PCN/ 17/022/C+N-US

Product range: M12 Circular Connectors

Title: M12 L-Code PFT

Details of the Product Changes

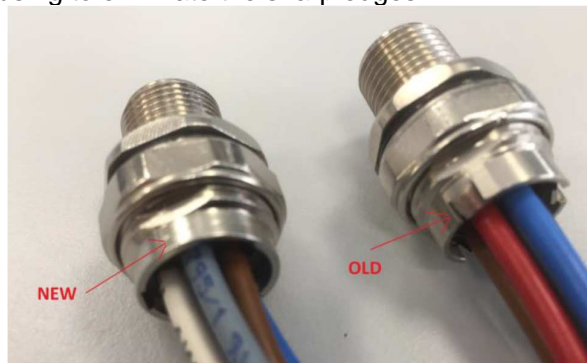
- a. Position and color changes of the wires. This change was implemented in order to comply with the new PROFINET specification.
